Docket No. 272 - Development and Management Plan Inspection

Segment 4a Underground Line

Date: September 26, 2007

Location: Singer Substation to Fairfield/Westport Town Line

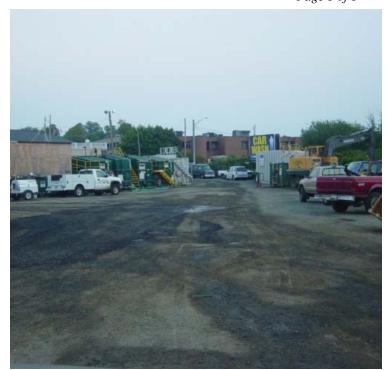
| Areas of Inspection | Observation | Recommended Action | Corrected Action |
|---|---|---|---|
| | A Private yard next to vault #28 has been stabilized with seed and hay mulch (noted 6/13). Vehicles are frequently noted parking on seeded areas. Approximately 70% vegetative growth | Continue to monitor to ensure adequate establishment of vegetation. 9/26/07 | Continue to monitor until final stabilization is achieved |
